## HISTORIC PRESERVATION COMMISSION

SUBJECT: Historic Area Work Permit # 956436 - revisions to previously approved HAWP

# CEPHAS SUMMER HOUSE

Addendum 1  
Staff Comments Emailed to Applicants 12.5.23

PULTHE - CEPHAS - SUMMERS HOME  
SECOND FLOOR & ROOF PLANS

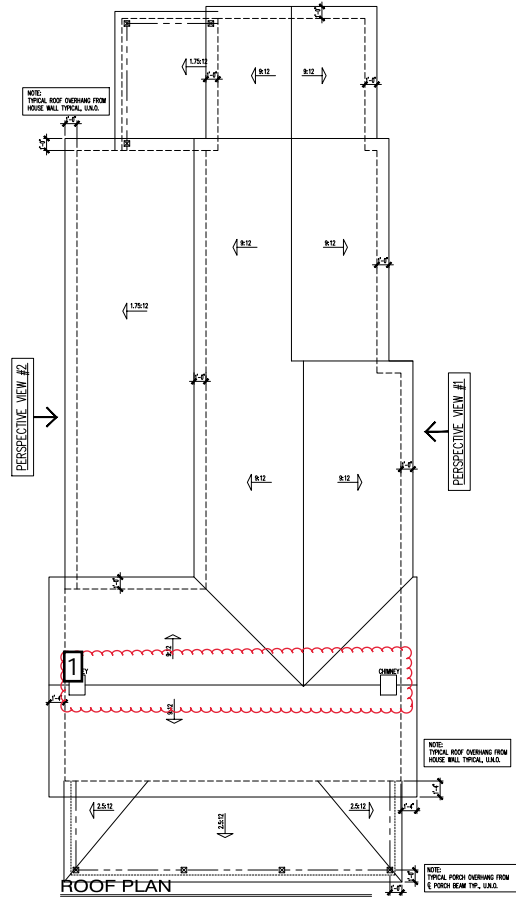
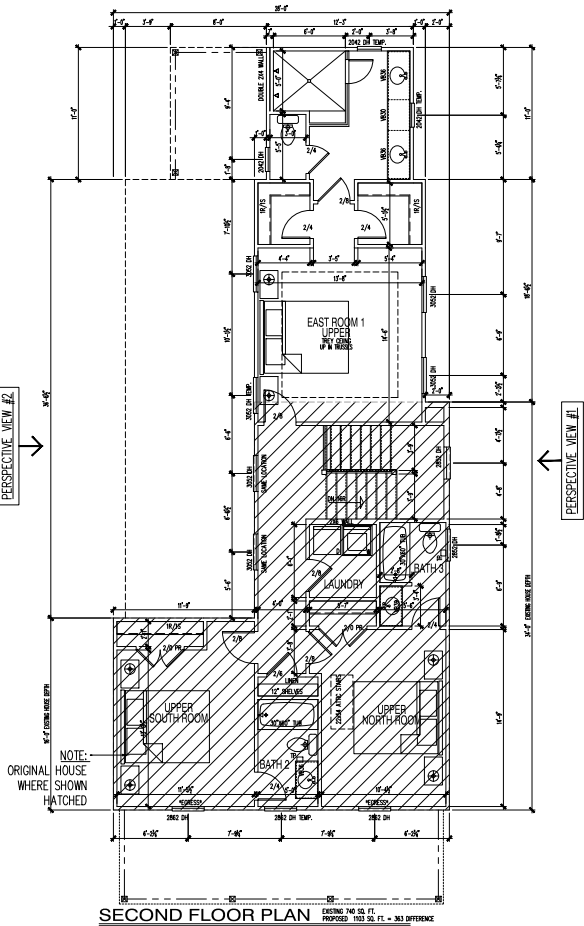
As part of the revised HAWP, the applicant shall submit a site plan and specifications for all hardscaping, driveways, paths, etc. Staff recommends that the driveway be gravel and the paths brick. The applicant should avoid the use of concrete.

As part of the revised HAWP, the applicant will submit documentation (drawing/photographs) for the relocation of the rebuilt chimneys. Please include the distance from the rake/edge of the roof to the chimney. Include a written narrative that outlines the structural reasons for their current position.

- 
-  Number: 1 Author: John.Liebertz Subject: Polygon Date: 12/5/2023 8:07:00 AM  
As part of the revised HAWP, the applicant will submit documentation (drawing/photographs) for the relocation of the rebuilt chimneys. Please include the distance from the rake/edge of the roof to the chimney. Include a written narrative that outlines the structural reasons for their current position.

- 
-  Number: 2 Author: John.Liebertz Subject: Polygon Date: 12/5/2023 8:07:13 AM  
As part of the revised HAWP, the applicant will submit revised specifications and photographs that show the 1 3/4" muntin width of the installed window.

- 
-  Number: 3 Author: John.Liebertz Subject: Line Date: 12/5/2023 8:07:17 AM  
The applicant will remove the installed TREX and install wood, tongue-and-groove, porch flooring. The floor should run perpendicular to the house.

- 
-  Number: 4 Author: John.Liebertz Subject: Polygon Date: 12/5/2023 8:07:22 AM  
As part of the revised HAWP, the applicant will submit revised drawings that show the design and specifications of the porch including all balustrades, railings, stair (including material of treads/risers), and posts at the stair landing. Staff recommends that the stair rail attaches directly to the existing columns. All profiles should be simple.

- 
-  Number: 5 Author: John.Liebertz Subject: Line Date: 12/5/2023 8:07:26 AM  
As part of the revised HAWP, the applicant will submit revised drawings that show the final grade, height of the porch floor, and pier foundation/posts. Staff recommends that the pier foundation/posts be clad with stone. Please include a written narrative about the final grade (code compliance, etc.).

- 
-  Number: 6 Author: John.Liebertz Subject: Text Box Date: 12/5/2023 8:07:31 AM  
As part of the revised HAWP, include locations and specifications for all lighting.

- 
-  Number: 7 Author: John.Liebertz Subject: Text Box Date: 12/5/2023 8:07:44 AM  
As part of the revised HAWP, include the specifications and locations of all gutters, downspouts, vents, etc.

1. Refer to the photographs below detailing the location for the rebuilt chimneys. They are located 12" from the edge of the roof. In order to provide structural support for the chimneys, steel angles lintels were required. These loads associated were transferred down to the roof girder trusses below.

1. Chimney's – addressed above.
2. Photos below detail the 1 ¾" muntin width of the updated window specifications.
3. The trex decking flooring will be removed. It will be replaced with solid wood. The floor will run perpendicular to the house as detailed on the revised drawings. Refer to Exhibit 2 for specifications.
4. At this time balustrades and railings will not be required on the front porch.
5. The final grade, height of the porch floor and pier/foundation posts can be found on the Resite/Lot Grading Plan and updated drawings. The pier/foundation posts will be clad with the same stone as approved on the foundation.
6. Lighting locations can be found on the updated drawings. Specifications for the light are detailed in Exhibit 2.
7. The locations of the gutters, downspouts and vents have been added to the updated drawings. Specifications can be found in Exhibit 2.

PULTE - CEPHAS - SUMMERS HOME  
 RIGHT SIDE ELEVATION

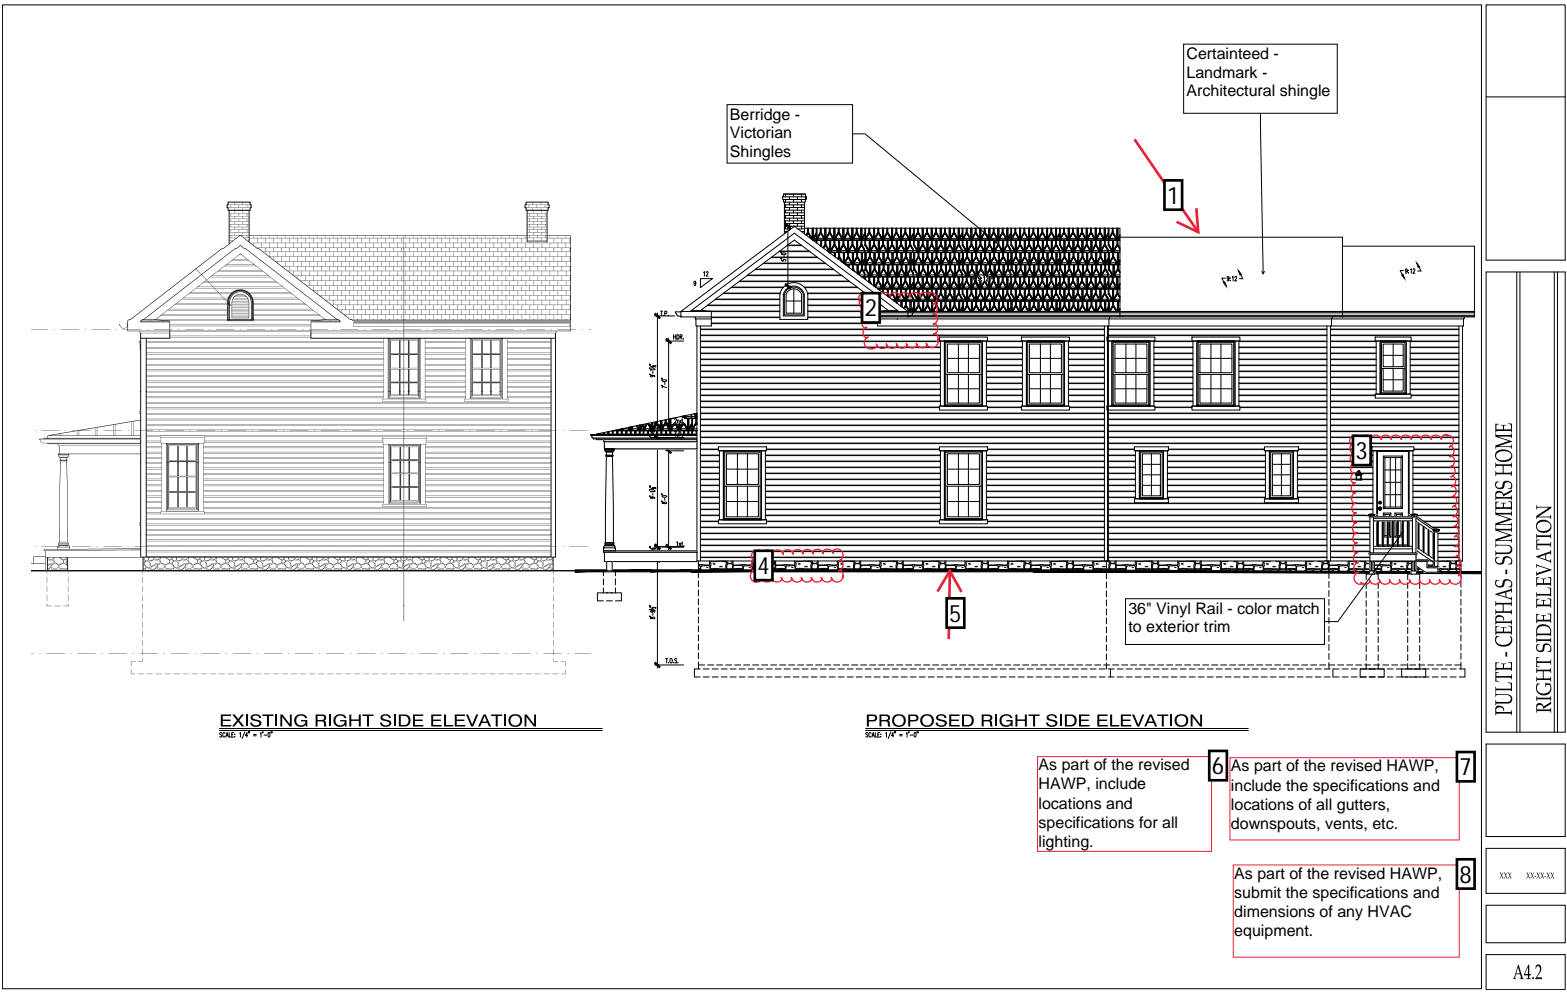
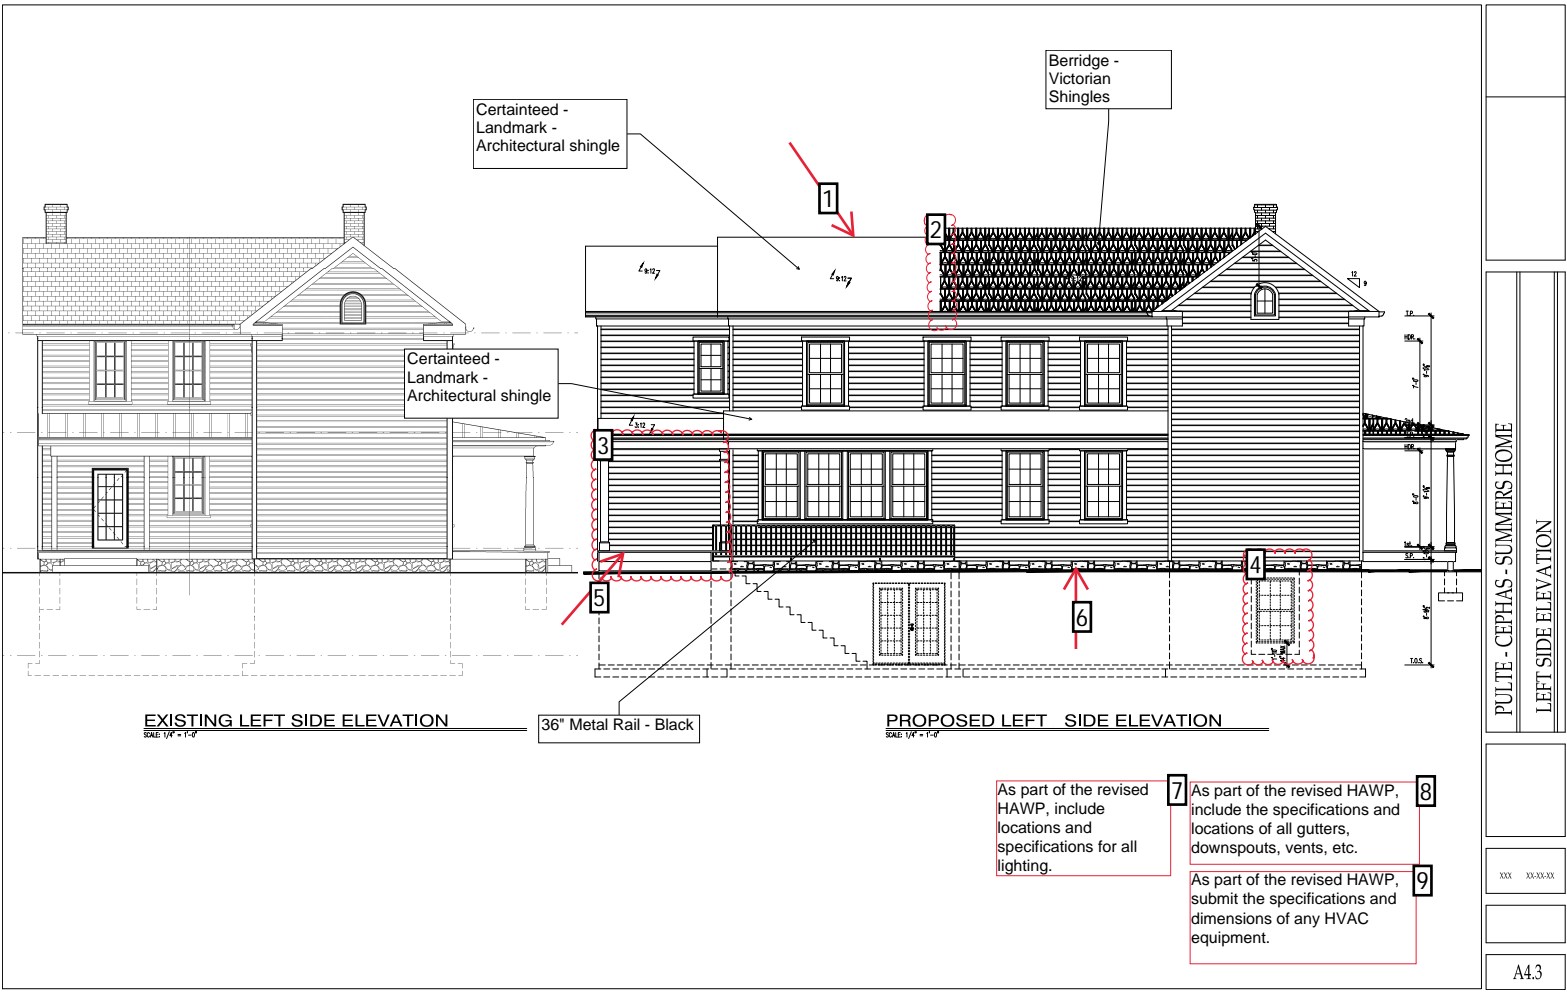
- 6 As part of the revised HAWP, include the specifications and locations of all gutters, downspouts, vents, etc.
- 7
- 8 As part of the revised HAWP, submit the specifications and dimensions of any HVAC equipment.

- 
- Number: 1 Author: John.Liebertz Subject: Line Date: 12/5/2023 8:07:55 AM  
As part of the revised HAWP, include specifications and locations of all ridge vents.

- 
- Number: 2 Author: John.Liebertz Subject: Polygon Date: 12/5/2023 8:08:00 AM  
As part of the revised HAWP, submit documentation (photographs) that show the as-built condition of the roof/cornice. If known, include a narrative that explains the discrepancy between approved and as-built condition.

- 
- Number: 3 Author: John.Liebertz Subject: Polygon Date: 12/5/2023 8:08:04 AM  
As part of the revised HAWP, submit revised drawings that show the proposed change to the orientation of the stair.

- 
- Number: 4 Author: John.Liebertz Subject: Polygon Date: 12/5/2023 8:08:09 AM  
As part of the revised HAWP, submit a detailed drawing/specification that shows the transition between the stone veneer foundation and siding.

- 
- Number: 5 Author: John.Liebertz Subject: Line Date: 12/5/2023 8:08:13 AM  
As part of the revised HAWP, include the location and specifications for all foundation-level windows.

- 
- Number: 6 Author: John.Liebertz Subject: Text Box Date: 12/5/2023 8:08:21 AM  
As part of the revised HAWP, include locations and specifications for all lighting.

- 
- Number: 7 Author: John.Liebertz Subject: Text Box Date: 12/5/2023 8:08:25 AM  
As part of the revised HAWP, include the specifications and locations of all gutters, downspouts, vents, etc.

- 
- Number: 8 Author: John.Liebertz Subject: Text Box Date: 12/5/2023 8:08:30 AM  
As part of the revised HAWP, submit the specifications and dimensions of any HVAC equipment.

3. The change to the orientation of the back door drawings and the Resite/Lot Grading Plan.
4. The stone veneer to siding detail has been updated below. This cap was required for the installation.
5. The location of all basement/foundation level drawings. The window specifications can be found in Exhibit 2.
6. Lighting locations can be found on the updated drawings. Specifications for the light are detailed in Exhibit 2.
7. The locations of the gutters, downspouts and vents have been added to the updated drawings. Specifications can be found in Exhibit 2.
8. The HVAC condensers have located on the updated drawings.

EXISTING REAR ELEVATION  
SCALE: 1/8" = 1'-0"

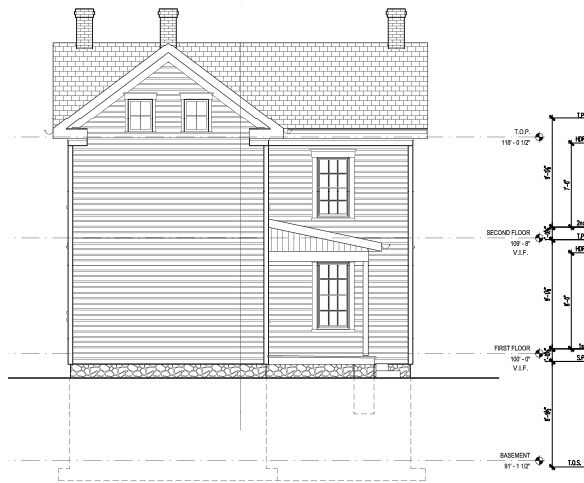
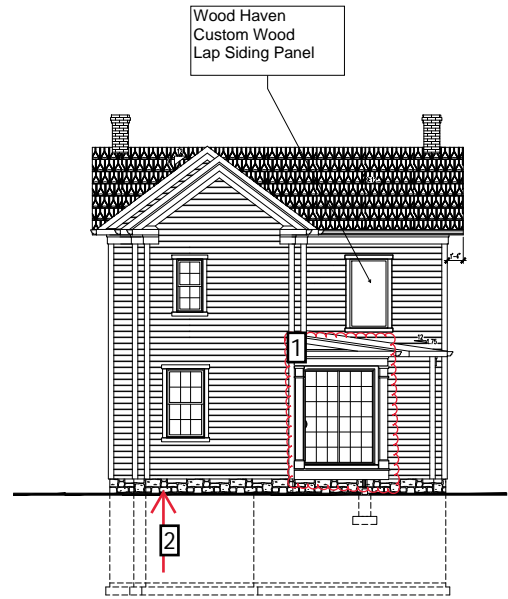
Number: 1 Author: John.Liebertz Subject: Line Date: 12/5/2023 8:08:46 AM  
As part of the revised HAWP, include specifications and

Number: 2 Author: John.Liebertz Subject: Polygon Date: 12/5/2023 8:09:35 AM  
As part of the revised HAWP, submit specifications/drawings for tin and asphalt shingle roofs.

Number: 3 Author: John.Liebertz Subject: Polygon Date: 12/5/2023 8:08:46 AM  
As part of the revised HAWP, the applicant will submit revised drawings that show the design and specifications of the rear porch including all balustrades, railings, stair (including material of treads/risers), posts at the stair landing, and treatment of the pier foundations/posts. Staff recommends that all profiles should be simple.

Number: 4 Author: John.Liebertz Subject: Polygon Date: 12/5/2023 8:09:35 AM  
As part of the revised HAWP, the applicant will submit drawings/specifications for the window well.

Number: 5 Author: John.Liebertz Subject: Line Date: 12/5/2023 8:09:40 AM  
The applicant will remove the installed TREX and install wood, tongue-and-groove, porch flooring. The floor should run perpendicular to the house.

Number: 6 Author: John.Liebertz Subject: Line Date: 12/5/2023 8:09:44 AM  
As part of the revised HAWP, the applicant shall submit the location and specifications for all foundation-level windows.

Number: 7 Author: John.Liebertz Subject: Text Box Date: 12/5/2023 8:09:48 AM  
As part of the revised HAWP, include locations and specifications for all lighting.

Number: 8 Author: John.Liebertz Subject: Text Box Date: 12/5/2023 8:09:52 AM  
As part of the revised HAWP, include the specifications and locations of all gutters, downspouts, vents, etc.

Number: 9 Author: John.Liebertz Subject: Text Box Date: 12/5/2023 8:09:58 AM  
As part of the revised HAWP, submit the specifications and dimensions of any HVAC equipment.

As part of the revised HAWP, include the locations and specifications for all lighting.

As part of the revised HAWP, include the specifications and locations of all gutters, downspouts, vents, etc.

As part of the revised HAWP, submit the specifications and dimensions of any HVAC equipment.

1. The location of all box vents are shown on the drawings. The location of the vents can be found in Exhibit 2.
2. The curb/parapet that was required for the terrace has been added to the updated drawings.

3. The updated drawings show the design of the rear porch balustrades, railings, and stair. Balustrade and railing specifications can be found in Exhibit 2.

4. The window well specifications can be found in Exhibit 2.
5. The trex decking flooring will be removed. It will be replaced with 1"x 4" tongue and groove wood. The floor will run perpendicular to the house as detailed on the revised drawings. Refer to Exhibit 2 for specifications.

8. The locations of the gutters, downspouts and vents have been added to the updated drawings. Specifications can be found in Exhibit 2.
9. The HVAC condensers have been located on the updated drawings.

Revised 05/23/2023

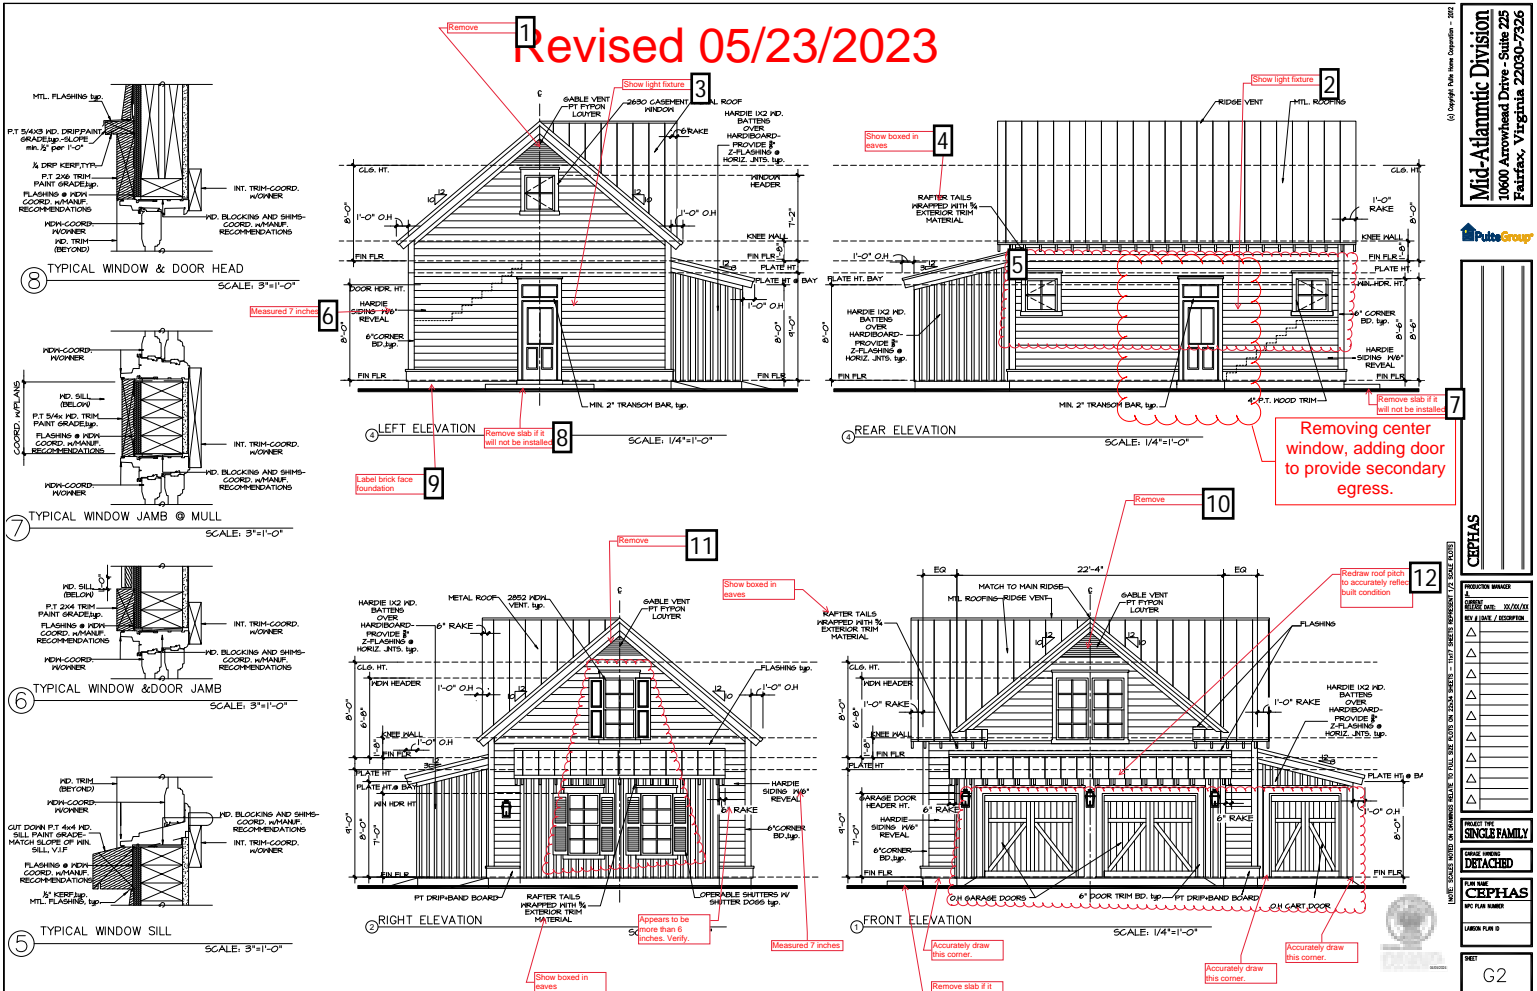
Number: 1 Author: John.Liebertz Subject: Polygon Date: 12/5/2023 8:10:11 AM  
For staff comments on rear porch, see Sheet A4.3.

Number: 2 Author: John.Liebertz Subject: Line Date: 12/5/2023 8:10:15 AM  
As part of the revised HAWP, the applicant shall submit the location and specifications for all foundation-level windows.

Number: 3 Author: John.Liebertz Subject: Text Box Date: 12/5/2023 8:10:19 AM  
As part of the revised HAWP, include locations and specifications for all lighting.

Number: 4 Author: John.Liebertz Subject: Text Box Date: 12/5/2023 8:10:23 AM  
As part of the revised HAWP, include the specifications and locations of all gutters, downspouts, vents, etc.

Number: 5 Author: John.Liebertz Subject: Text Box Date: 12/5/2023 8:10:29 AM  
As part of the revised HAWP, submit the specifications and dimensions of any HVAC equipment.

1. Rear porch – see above.
2. The location of all basement/foundation level windows have been shown on the updated drawings. The window specifications can be found in Exhibit 2.
3. Lighting locations can be found on the updated drawings. Specifications for the light are detailed in Exhibit 2.
4. The locations of the gutters, downspouts and vents have been added to the updated drawings. Specifications can be found in Exhibit 2.
5. The HVAC condensers have been located on the updated drawings.
